SUBJECT: Town of Huntington
Suffolk County, NY
Contract Documents and Specifications
Contract No. ENV94-01/0-C
Interim Remedial Program
Huntington/East Northport Landfill
Addendum No. 1

ADDENDUM NO. 1

Addendum No. 2

SHEET SK-C1

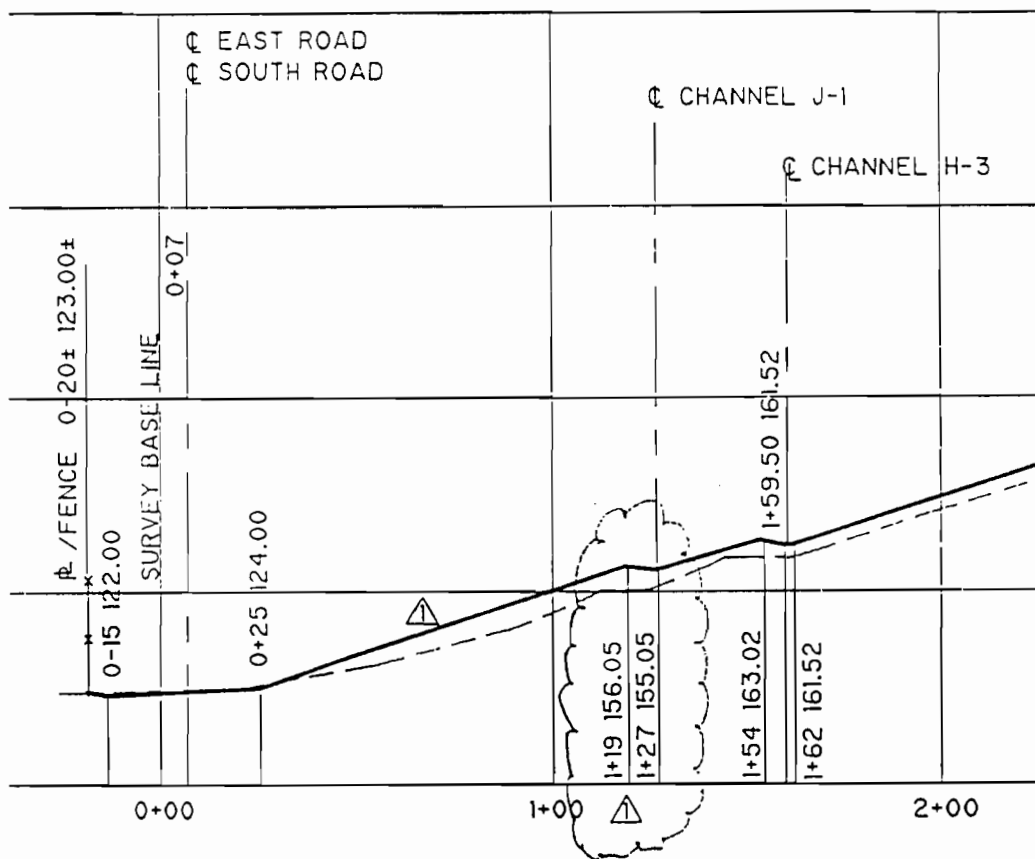
<u>SHEET NO.</u>	<u>DESCRIPTION OF CHANGE</u>
C-8	1. Section 11/C-4. Delete the elevation 111.00 at station 0+68 (East Road)
C-9	1. Section 12A/C-4. Revise as indicated in SK-C1.
C-12	1. Section 22A/C-5. Revise as indicated in SK-C2.
C-14	1. Centerline Channel "J" profile. Reverse the callouts for channel J2 and J1 from that shown such that Channel J1 limits are from Section 19E to Section 22A and Channel J2 limits are from Section 13E to Section 19A.
C-15	1. Centerline Drainageway "V" profile. Revise as indicated in SK-C3.
C-16	1. Centerline West Drain profile. Revise as indicated in SK-C4. 2. Centerline East Drain profile. Revise as indicated in SK-C5. 3. Centerline Downdrain Z profile. Correct the spelling of the word "AS" to read "GAS" in note Perimeter... Inv. 102.50.
C-18	1. Centerline East Road profile. Revise elevation at Station 7+15 to 108.90 and at Station 8+90 to 108.38.
C-21	1. Passive Gas Vent Conversion to Active Vent. Correct the spelling of the word "PVF" to "PVC" in the note 6"... Assembly, and the word "Post" to "Port" in the note 3/8" Test Post.

Added Note

SHEET 5K-C7

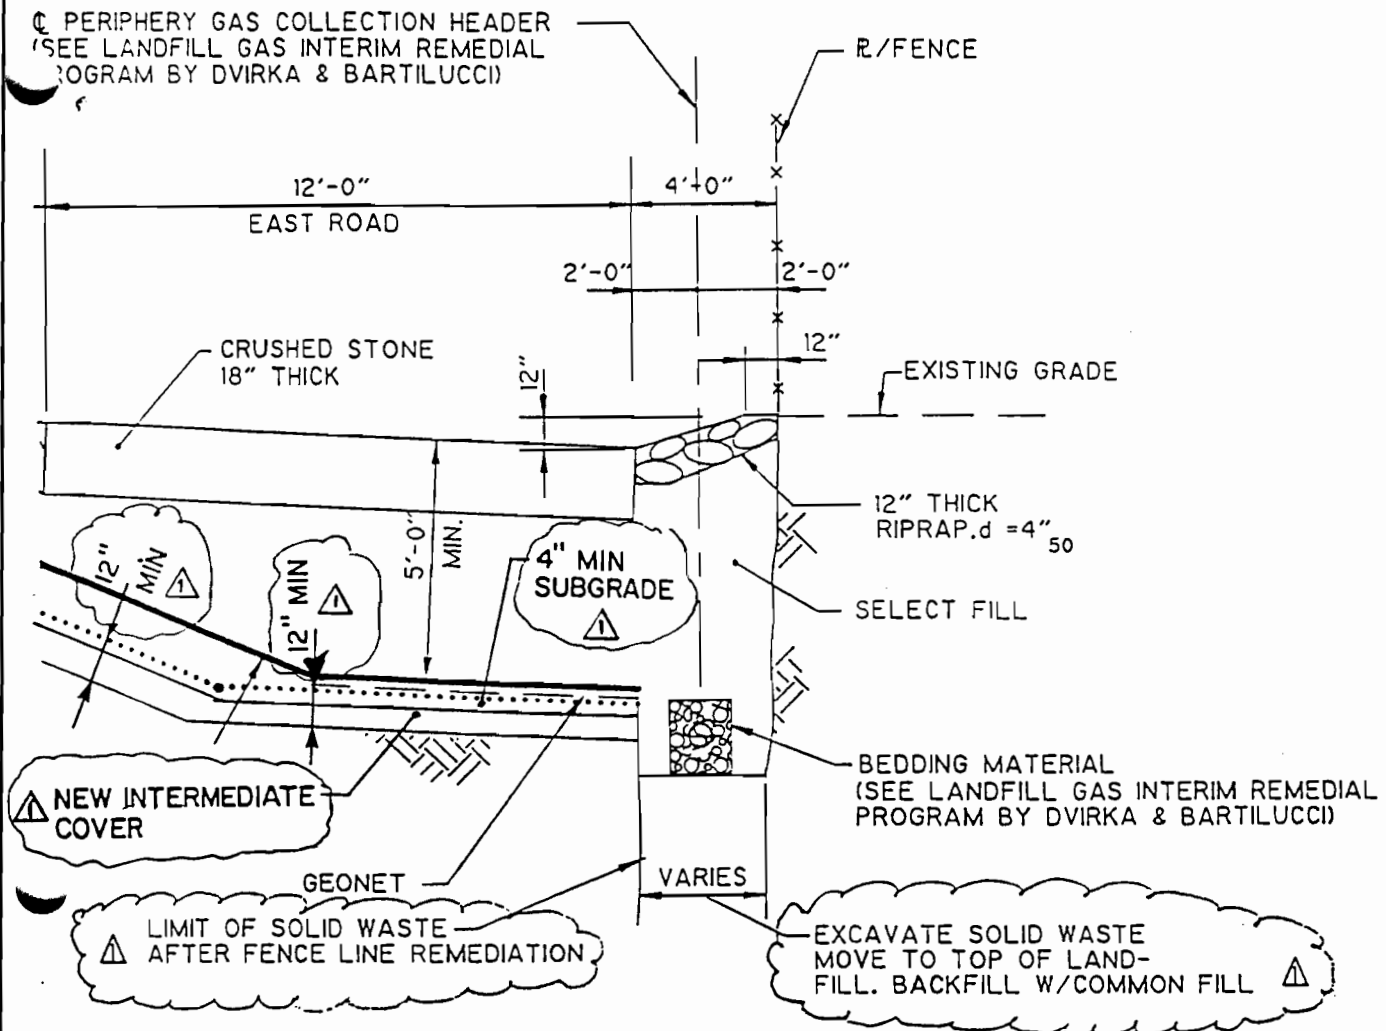
C-22	1. Typical Toe of Landfill Detail for Sections 12 and 10 East (At Catch Basin). Revise as indicated in SK-C6. 2. Typical Toe of Landfill Detail for Sections 20, 21, and 22 East (At Gas Manholes). Revise as indicated in SK-C7. 3. Typical Toe of Landfill Detail for Sections 20, 21, and 22 East (No Gas Manholes). Revise as indicated in SK-C8. 4. Typical Toe of Landfill Detail for Sections 9 and 9A (At Gas Manholes). Revise as indicated in SK-C9. 5. Typical Toe of Landfill Detail for Sections 1, 2 and 3 North. Revise as indicated in SK-C10. 6. Typical Headwall Detail and Recharge Basins. Revise as indicated in SK-C 11A and SK-C11B.

Note Corrected

SHEET 5K-C11B

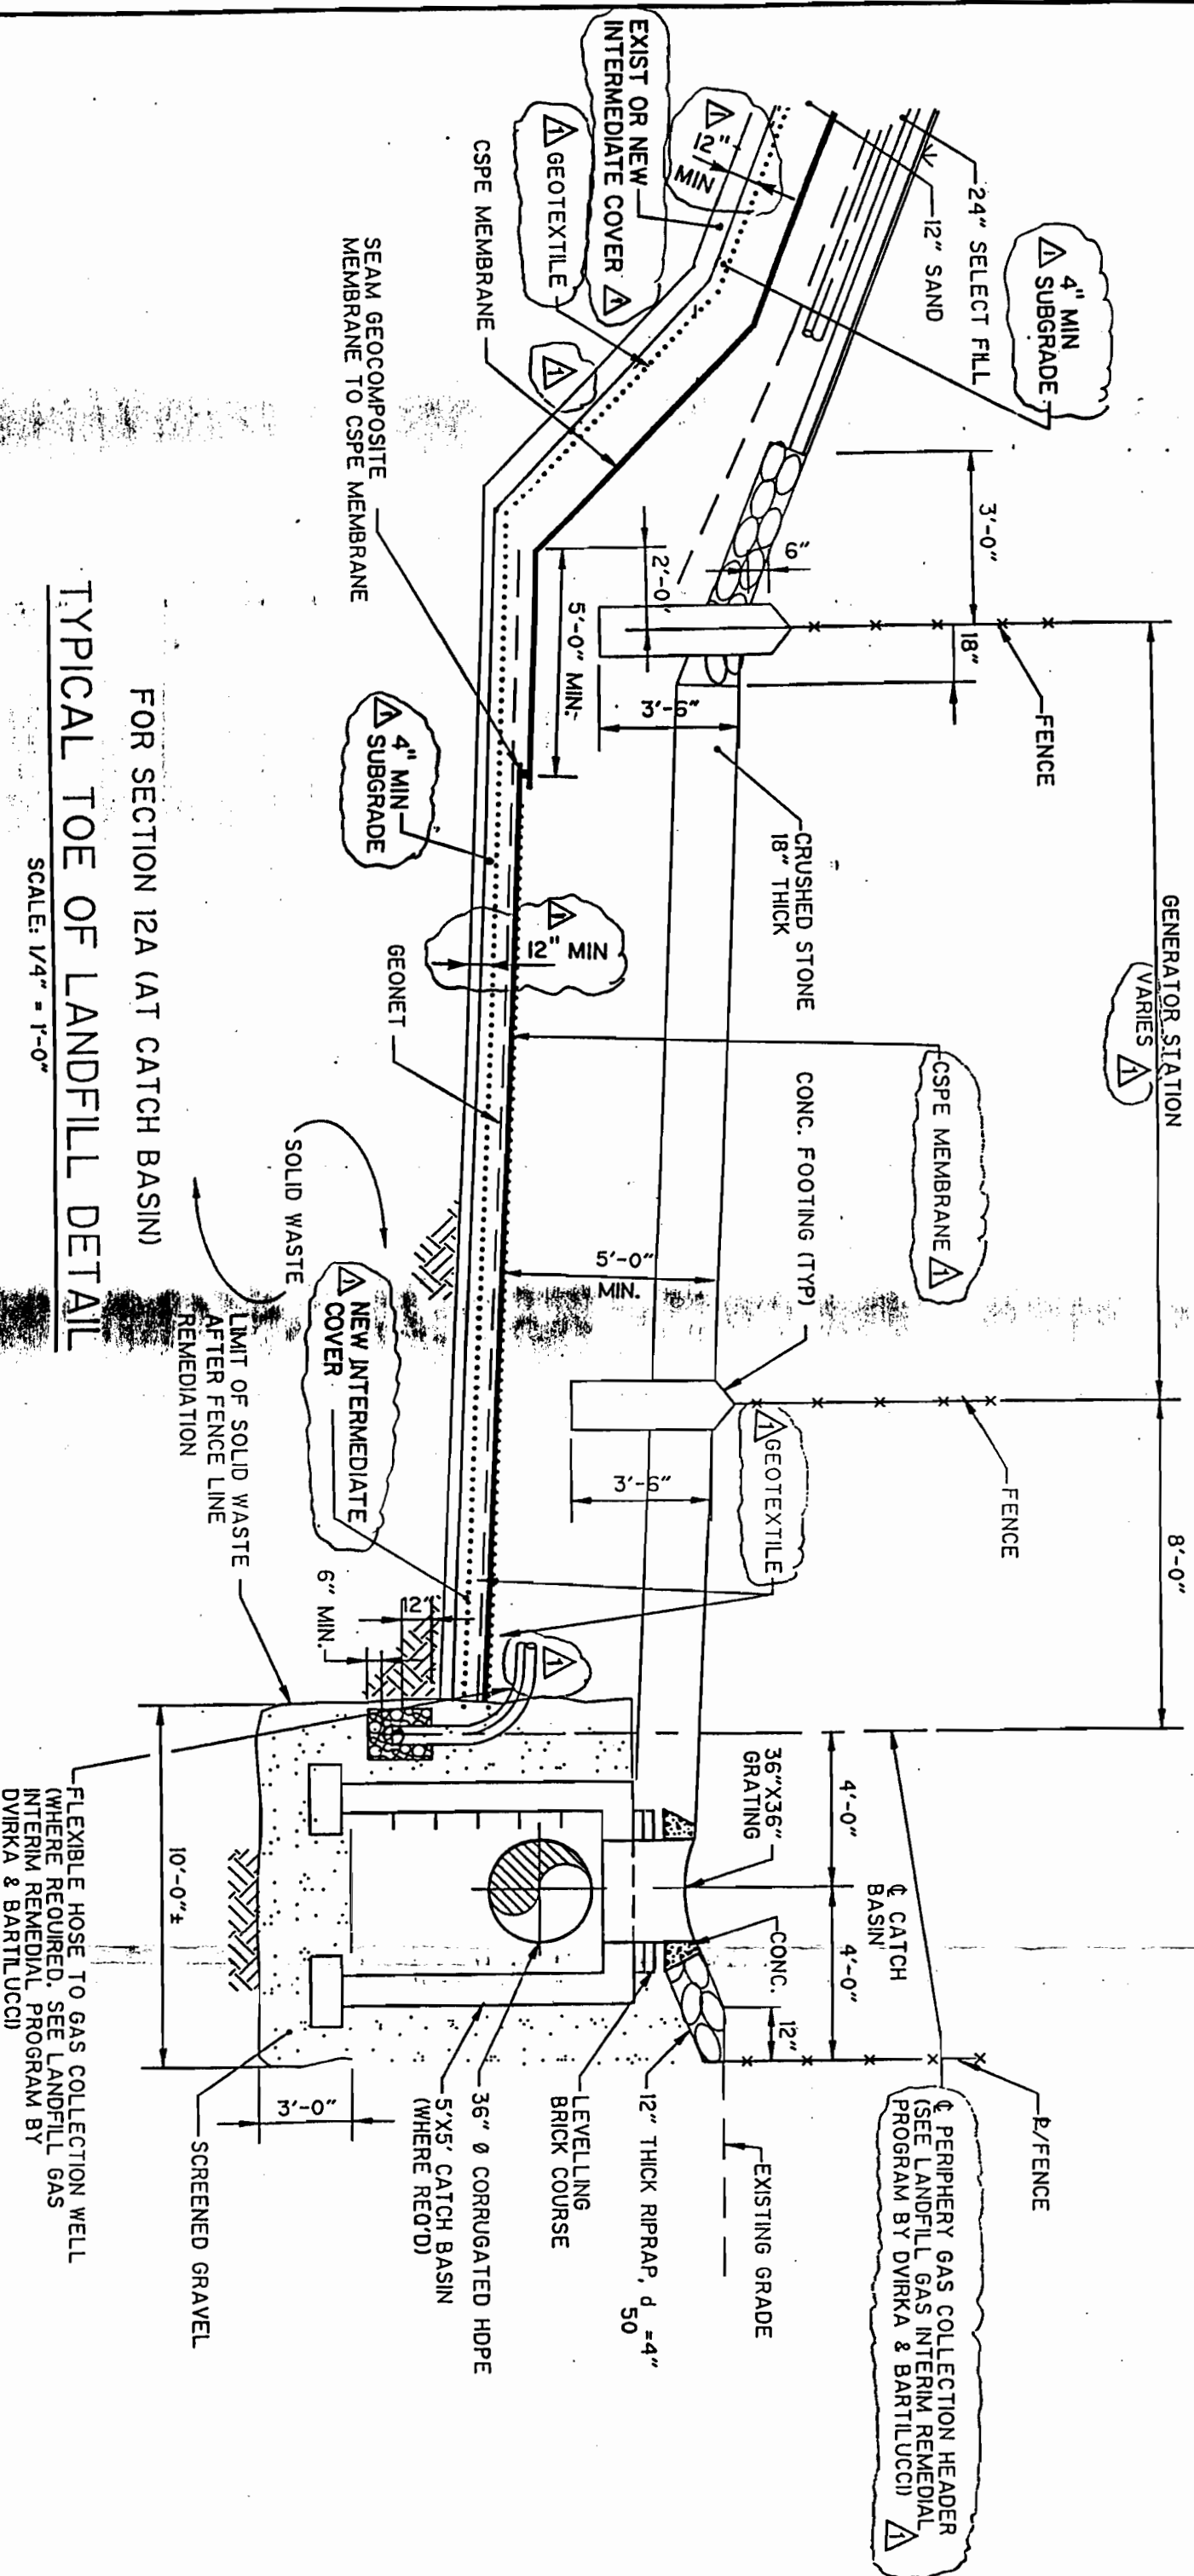
Notes Added & Corrected

Notes Added & Corrected SHEET 5K-C12

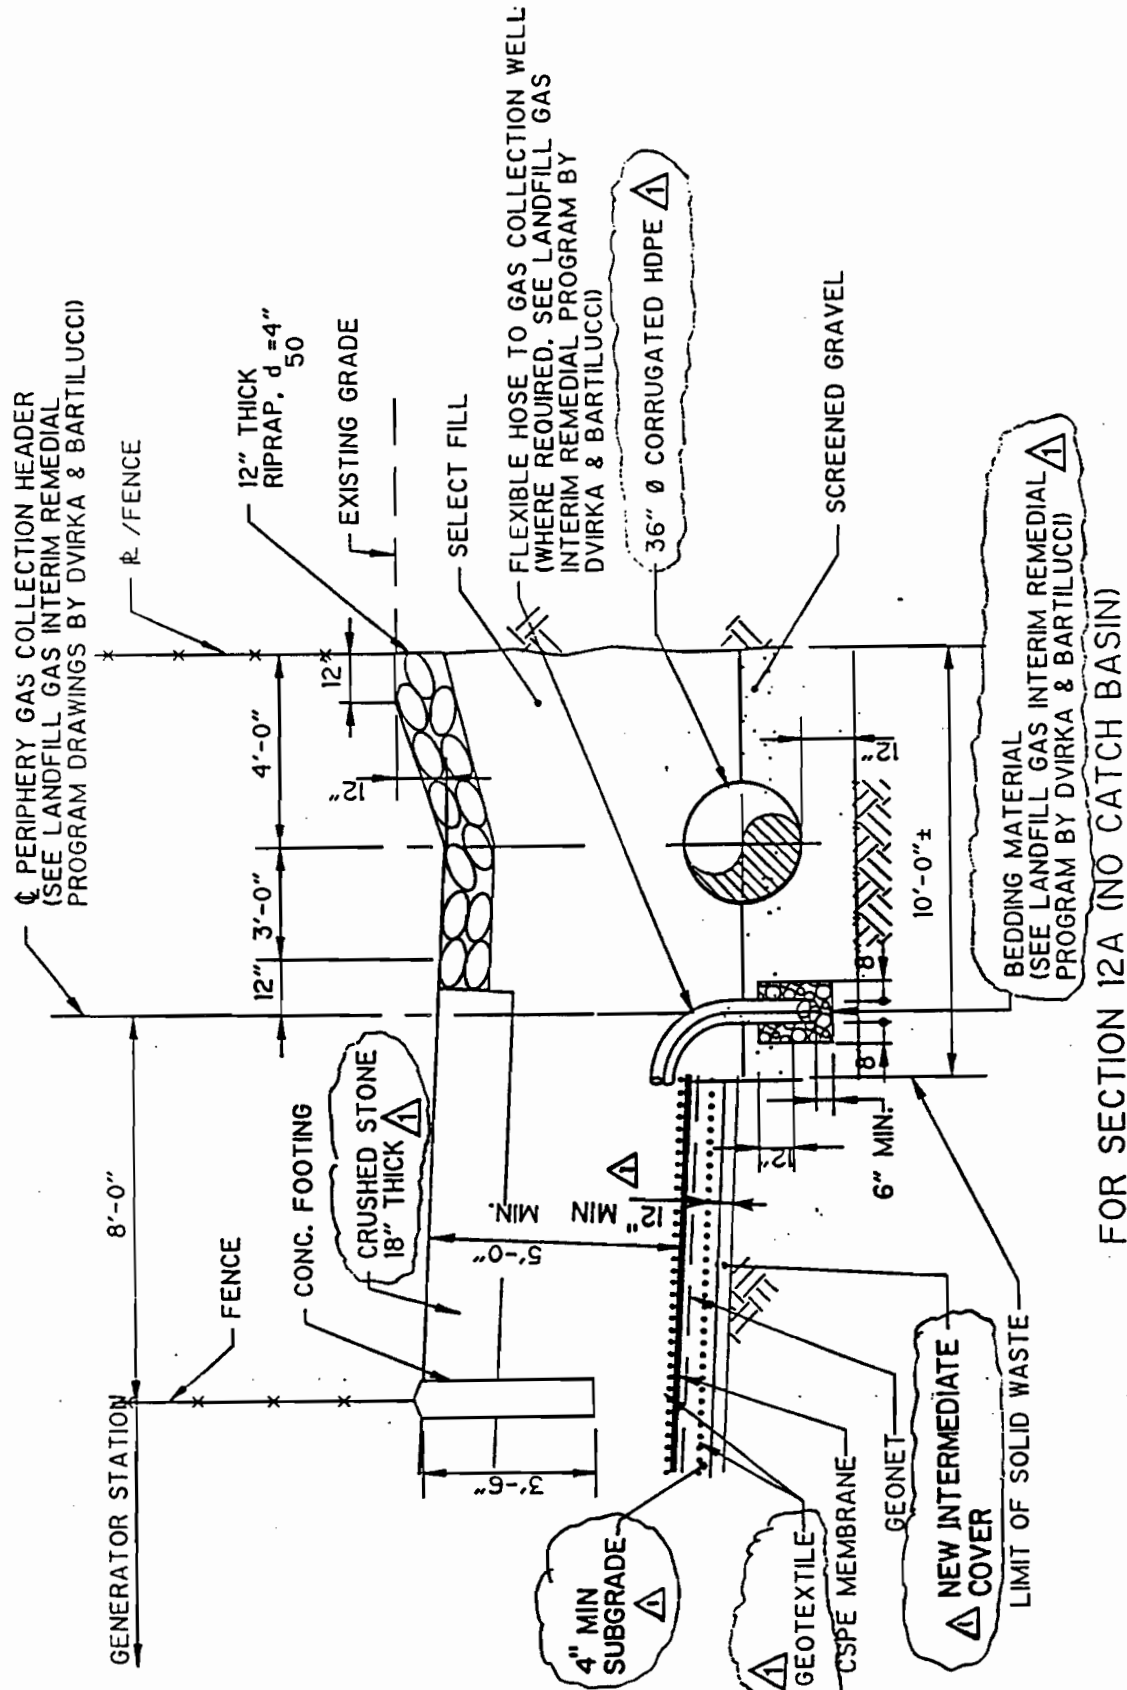
1. Typical Toe of Landfill Detail for Section 12A (At Catch Basin). Revise as indicated in SK-C12.
2. Typical Toe of Landfill Detail for Section 12A (No Catch Basin). Revise as indicated in SK-C13.
3. Add the Details and Notes as indicated in SK-C14.

SHEET 514-C15

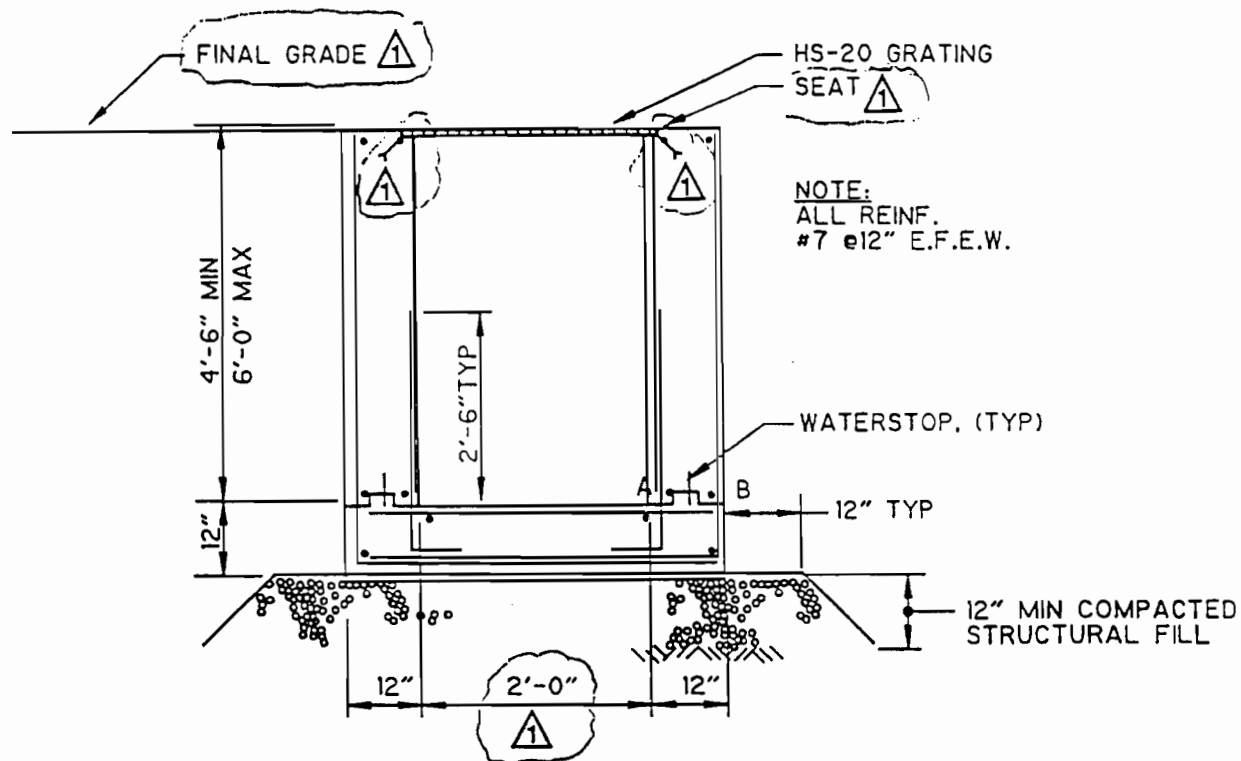
1. Section a Trench. Revise as indicated in SK-C15.
2. Downdrain Cleanout Detail. Correct the spelling of the word "CONNEC" to read "CONNECT" in note Special Metal Pipes.

C) CONTRACT DRAWING 10 OF 16

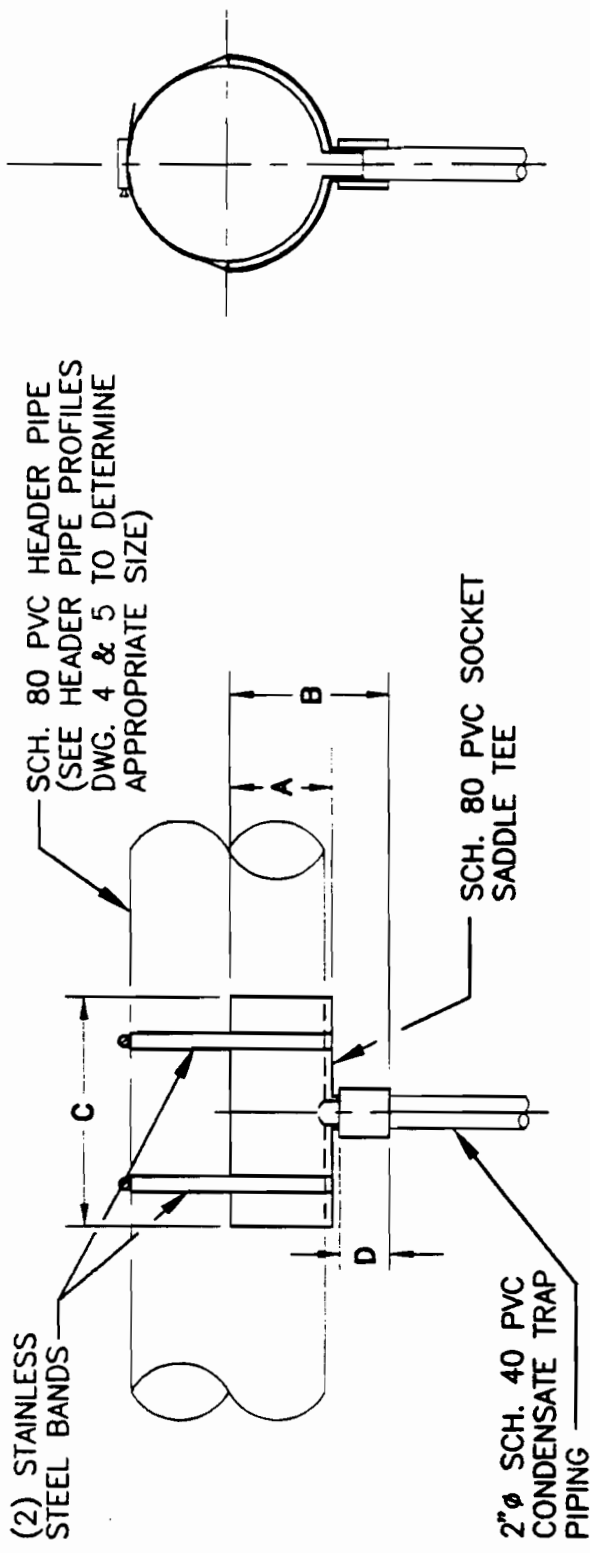
1. Add new detail "SOCKET SADDLE TEE DETAIL" as shown on attached Sketch 1.
2. Revise CONDENSATE TRAP AND ISOLATION VALVE MANHOLE CD-1,3,4, AND 5 DETAIL as shown on attached Sketch 2.
